Response to ORES Comments Compliance Filing Package 1

Hoffman Falls Wind Project

Matter No. 23-02976

Hoffman Falls Wind LLC

Figure 1. Wind Turbine Setbacks

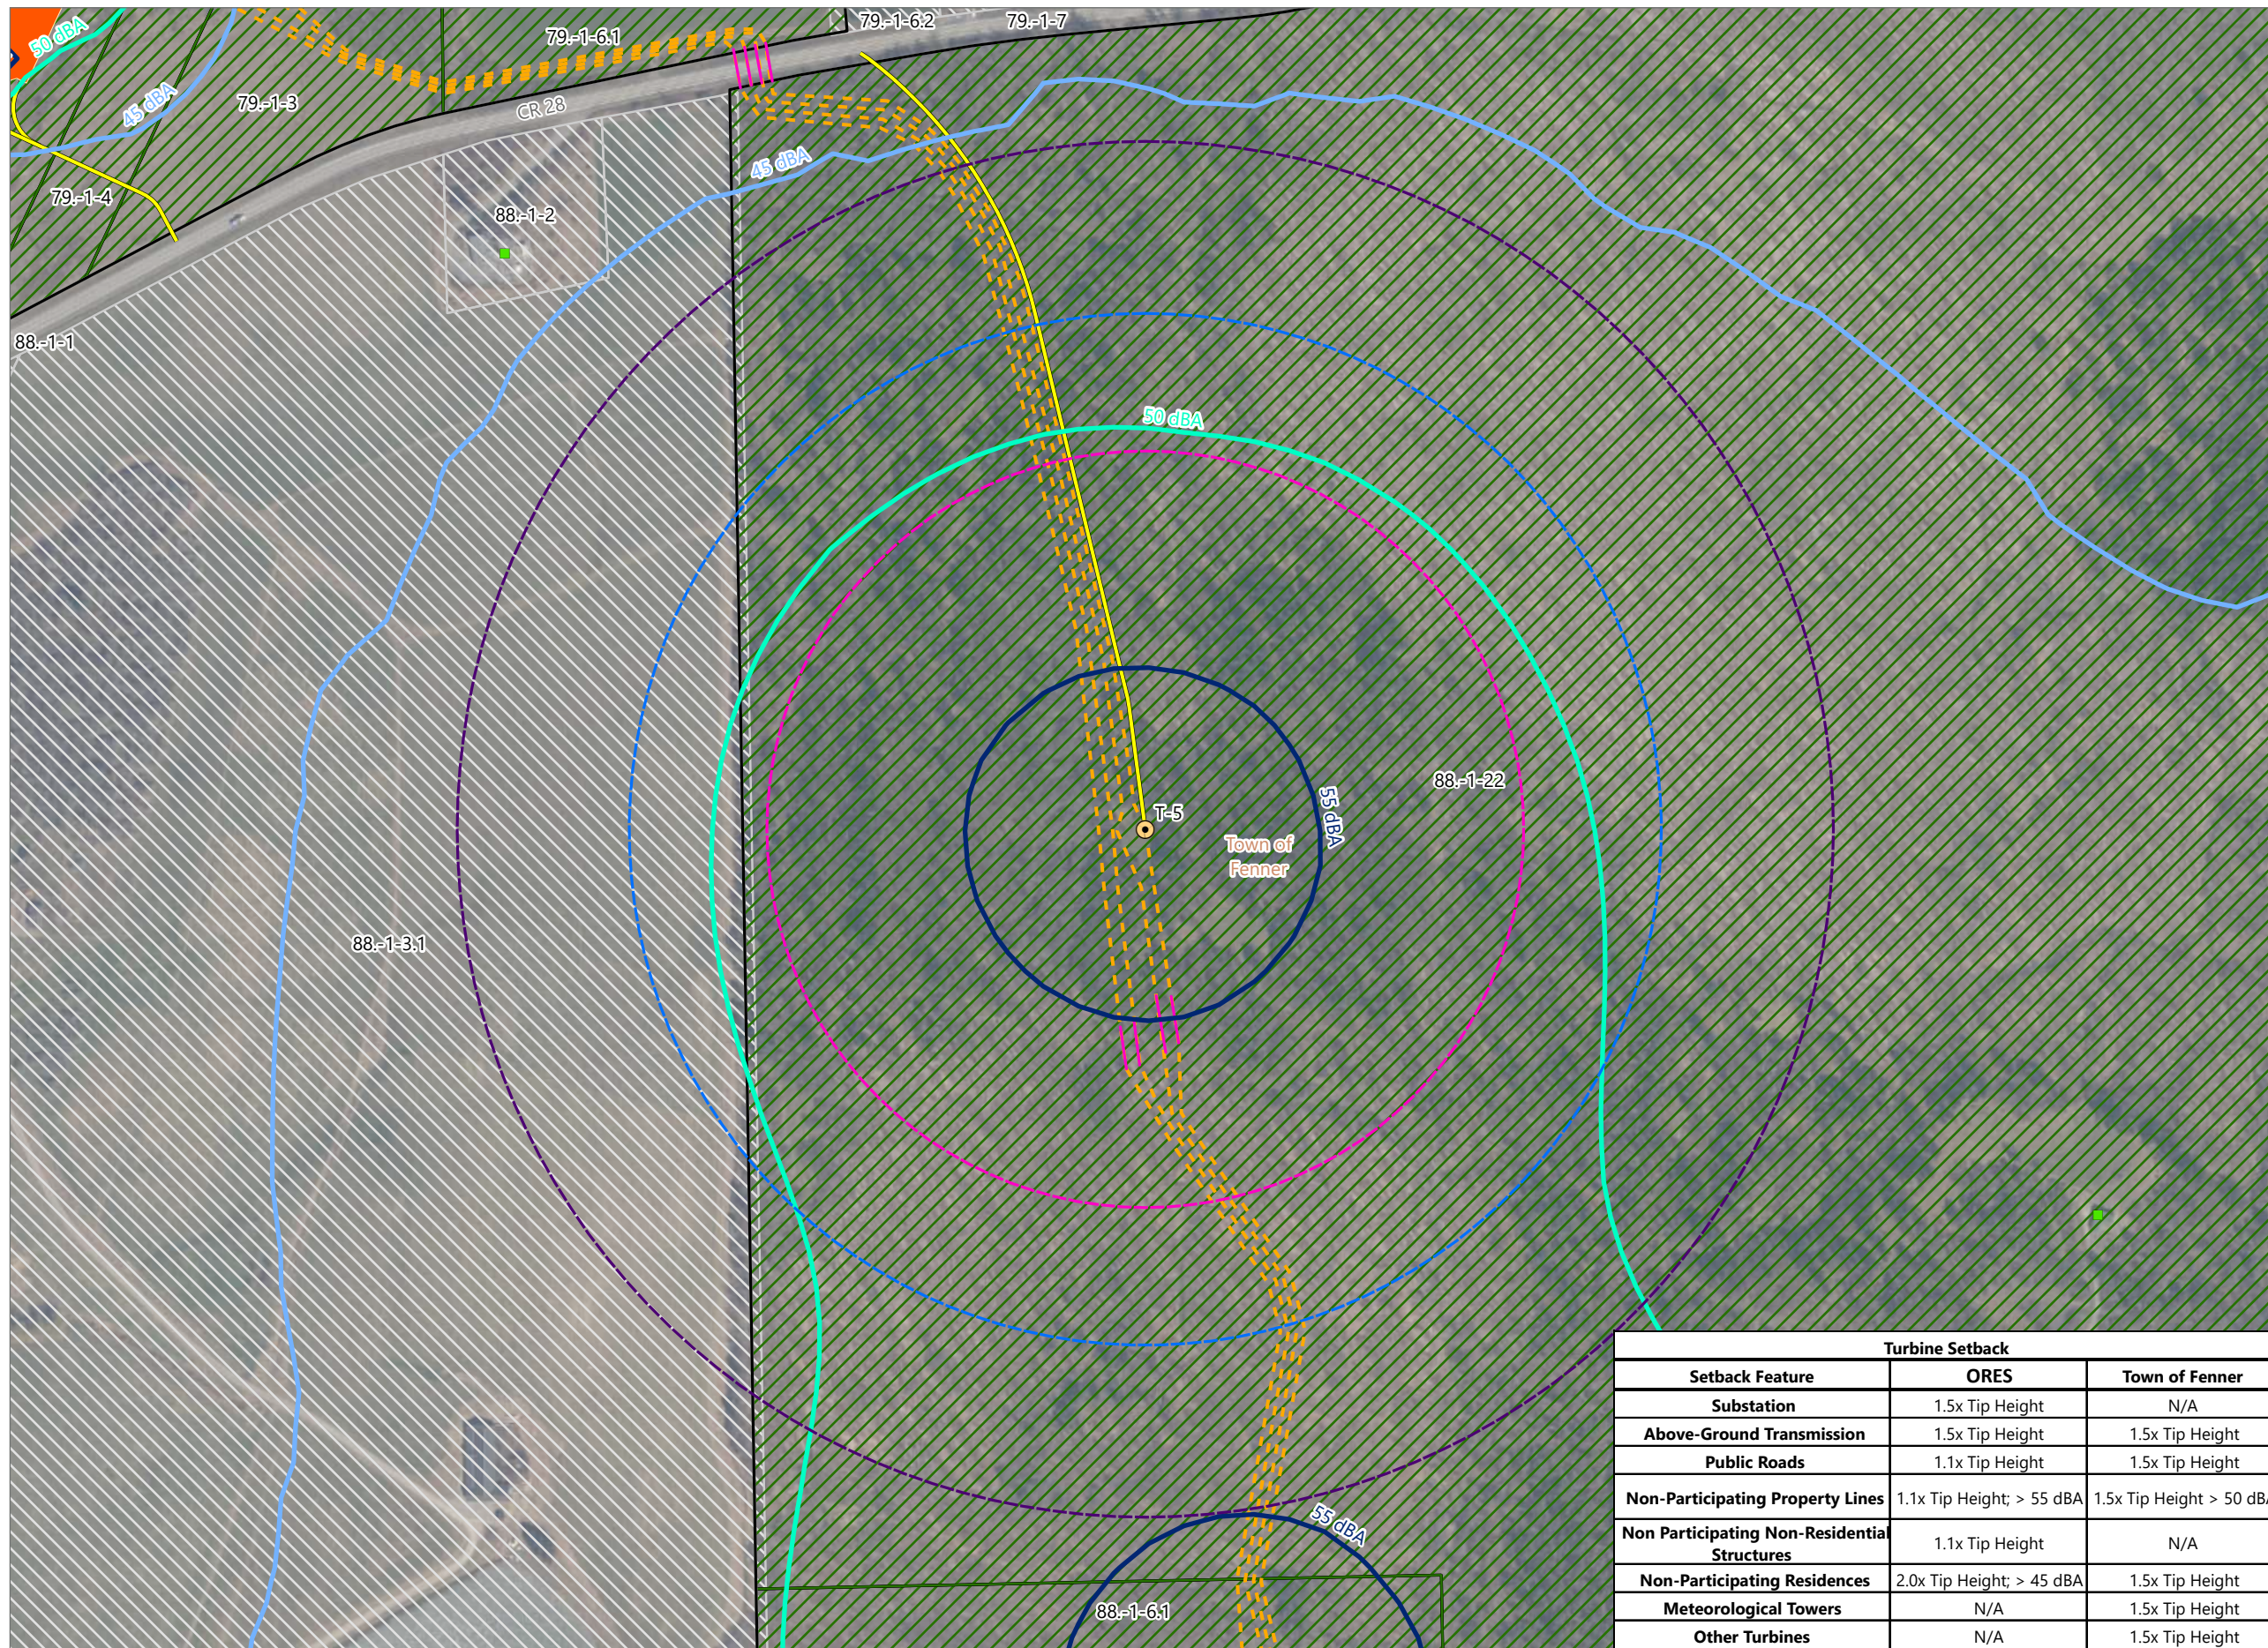
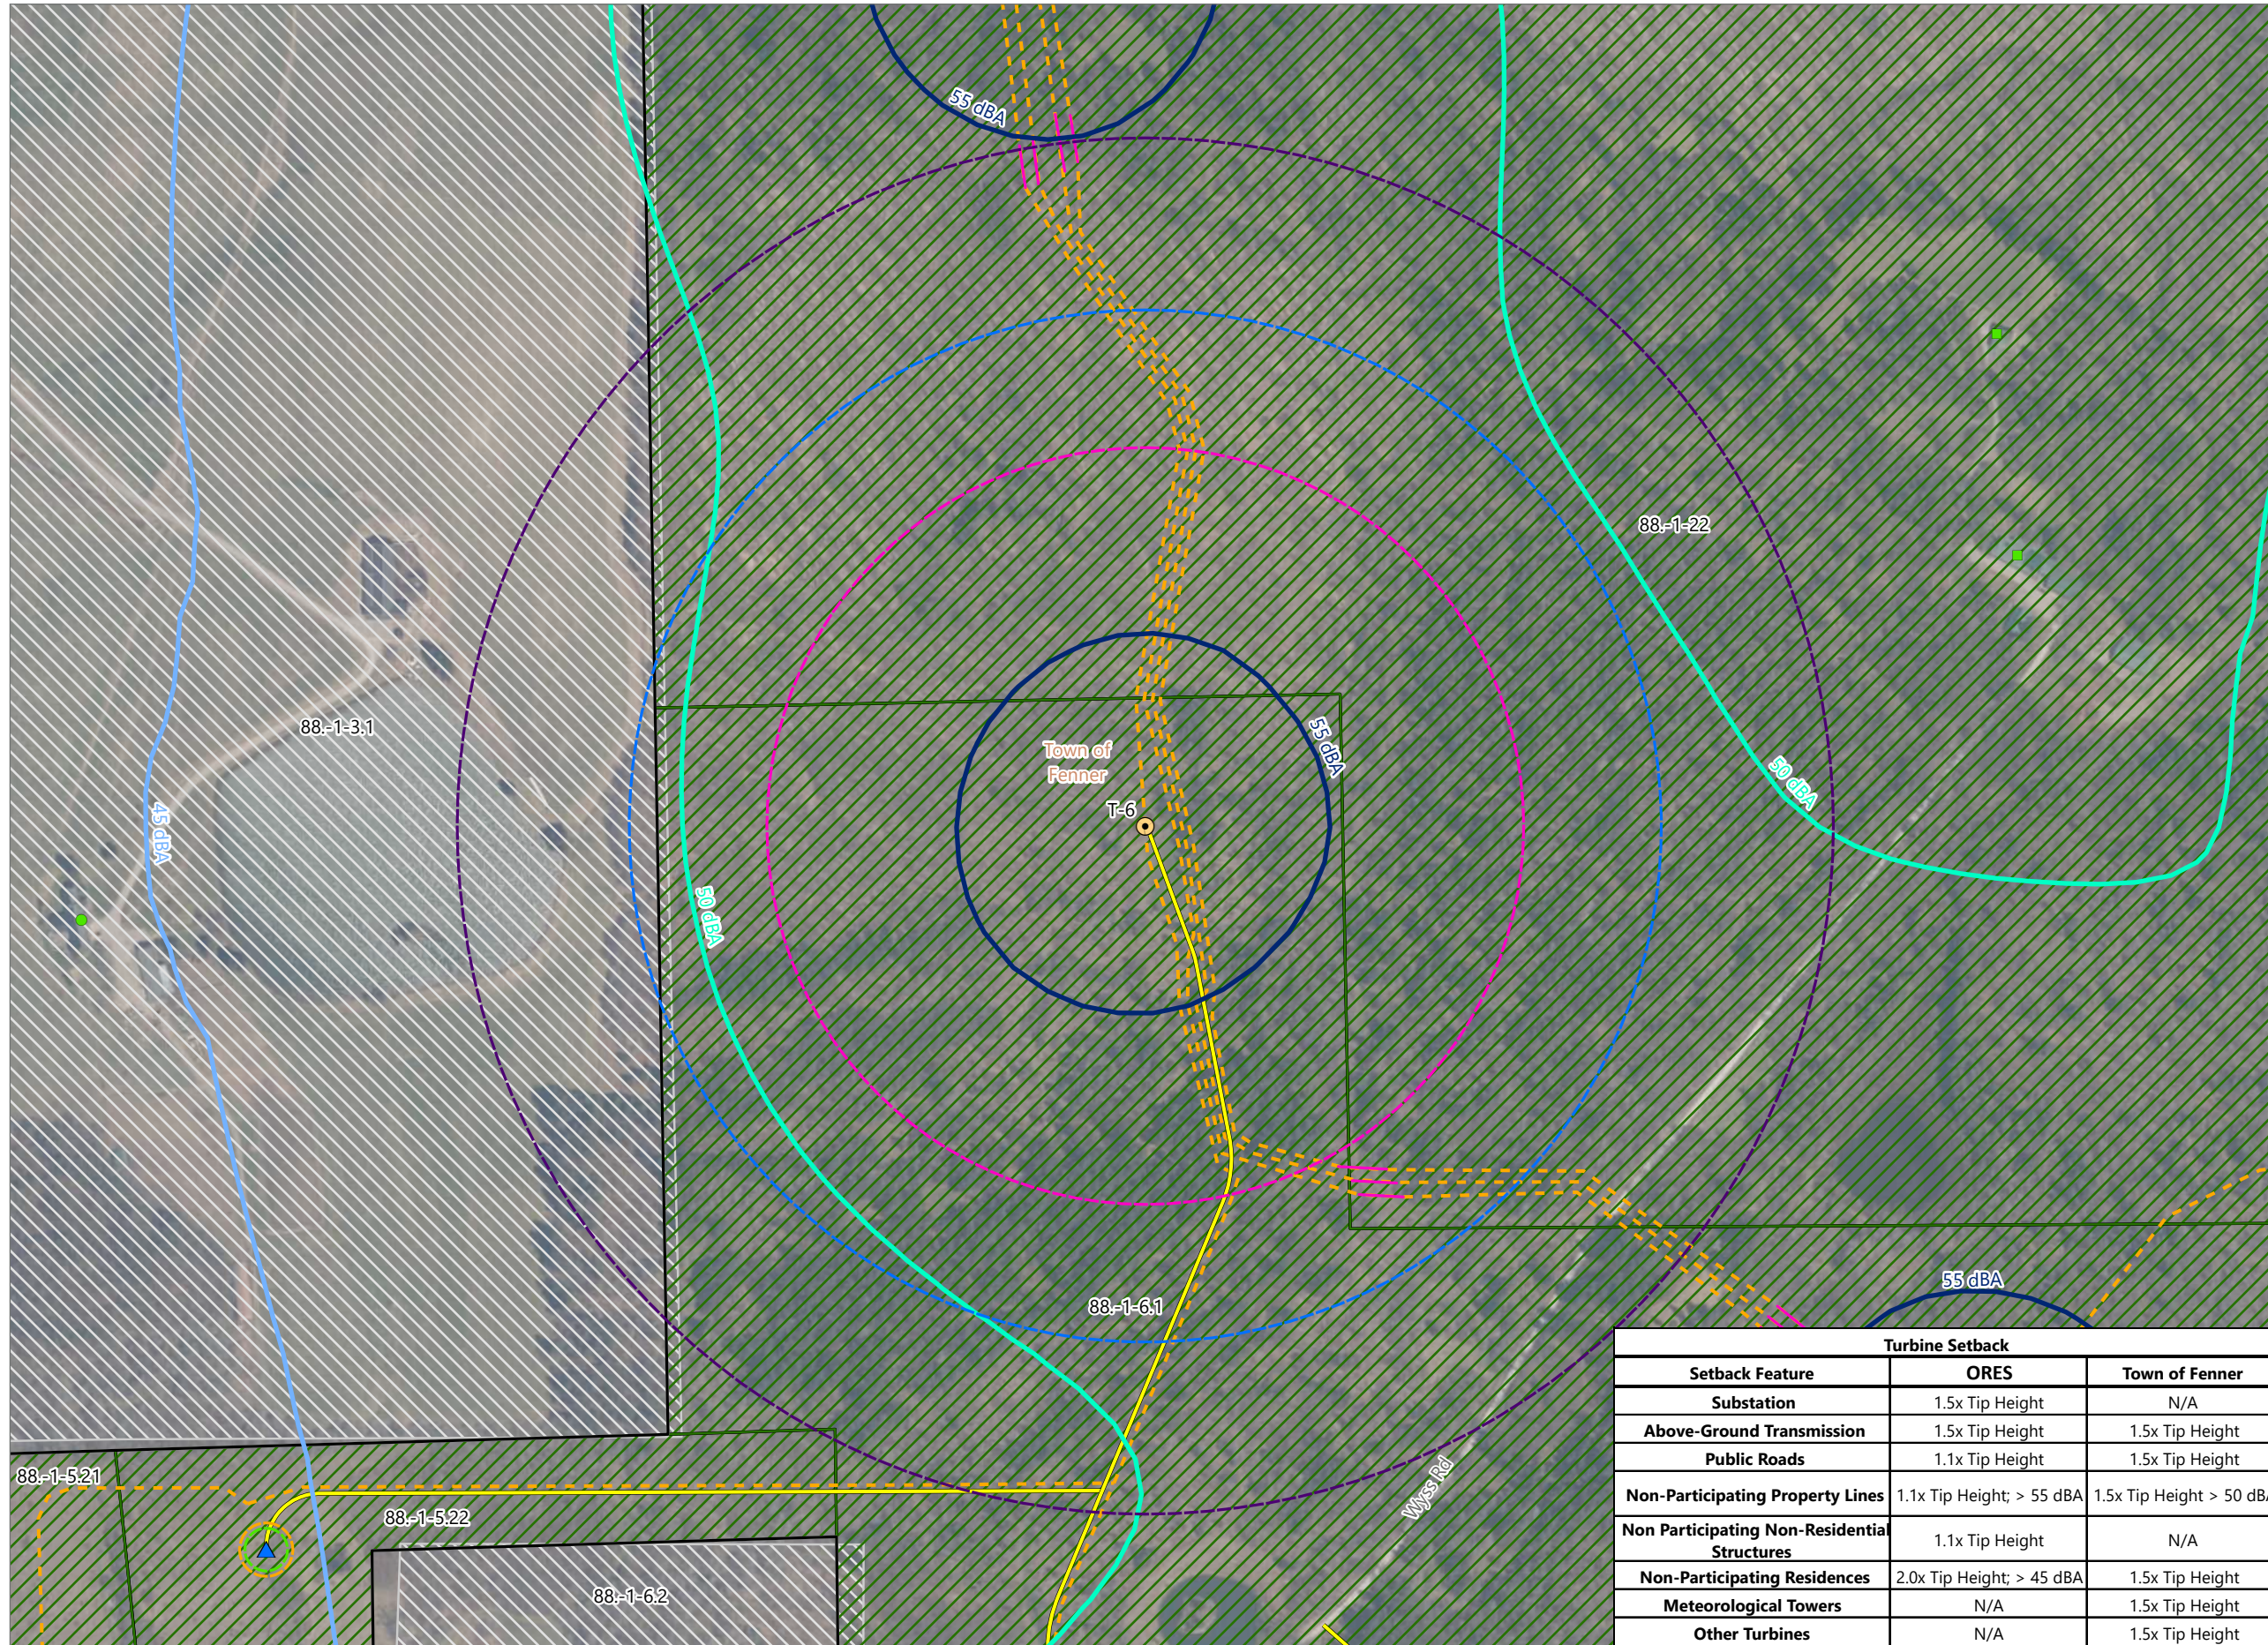
1. Please provide demonstration of compliance with ORES and local setbacks and the supporting spatial data.

Response: A demonstration of compliance with ORES and local setbacks is provided in Figure 1, which is attached to this filing along with the supporting spatial data.
